PRE-APPEAL BRIEF REQUEST FOR REVIEW

For: APPARATUS FOR PORTION
CUTTING OF FOOD PRODUCTS OR
SIMILAR ITEMS

ARGUMENTS IN SUPPORT OF PRE-APPEAL BRIEF REQUEST FOR REVIEW

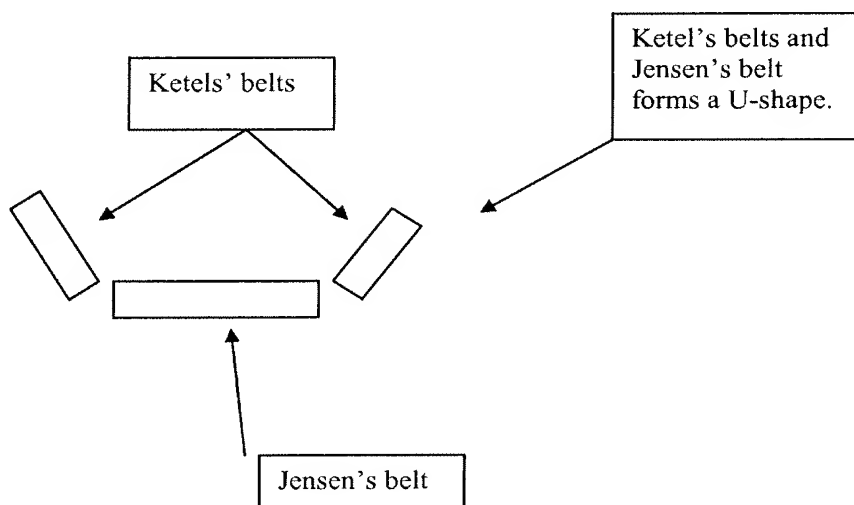
As recognized by the Examiner, Jensen does not teach the conveying means having two conveyors forming a V-shaped configuration. For this reason, the Examiner has cited the Ketels patent and its Fig. 1 in particular. Furthermore, the Examiner has asserted that it would be obvious to flank Jensen's belt with a pair of angled belts, in the manner that Ketels' conveyor belts 2.1 flank the convex supports 2.3 disposed between them as represented by the following sketch that was incorporated into the Examiner's rejection:

However, this position ignores basic facts of the nature and use of the devices of these two patents which make the Examiner's position impractical and most certainly not obvious.

Jensen's conveyor is wider than the products it is designed to convey such that placing of outwardly angled flanking conveyors as shown in the Examiner's figure above would serve no useful purpose since they would be incapable of contacting the products being conveyed. Put another way, the flanking conveyors 2.1 of Ketels are specifically designed to cooperate with supports 2.3 that are pressed into the work being conveyed and without such smaller-than-the-product conveying supports, the conveyors 2.1 cannot function to convey the product. Thus, it cannot be seen how it would be obvious to apply the flanking conveyors 2.1 of Ketels to Jensen's apparatus without the internal product supports that they are specifically designed to co-act with. This argument has not been addressed by the Examiner.

FIG. 2

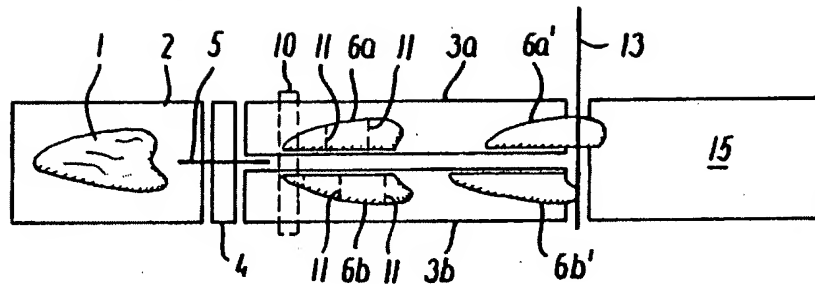
First, the Ketels conveying arrangement is designed specifically for the conveying of decapitated and gutted whole fish with the supports 2.3 being pressed into the interior of the body cavity such that the fish is held between the flanking conveyors 2.1 and the supports 2.3 for conveyance. In contrast, as can be seen from Fig. 2 of the Jensen reference copied below

Still further, as was pointed out to the Examiner, it would not be obvious to apply the conveying arrangement 2.1, 2.3 in place of the conveyor 2 of Jensen et al. because it would decrease the utility of Jensen et al.'s device. That is, Jensen et al.'s apparatus is designed to cut a variety of meat and fish products (what appear to be a chicken breast filets being shown in the drawings), while the conveyor of Ketels is designed specifically for whole fish from which the head and bones have been removed, the convex supports 2.3 being specifically designed to enter into the stomach cavity of the fish body as shown in Fig. 3 of the Ketels reference. Clearly, it would not be obvious to limit the general utility of Jensen's apparatus by modifying it based on the limited utility conveying arrangement of Ketels, and it would not be obvious to take only part of Ketels' conveying arrangement and add it to that of Jensen when it could serve no useful purpose to do so as is explained in the preceding paragraph. Thus, on the one hand, Ketels's conveying arrangement is unsuitable for Jensen's meat and fish utility purposes, and on the other hand, taking only the part selected of Ketels apparatus selected by the Examiner produces an arrangement where the flanking conveyors cannot function. The Examiner's statement that these two patents are relevant to each other simply
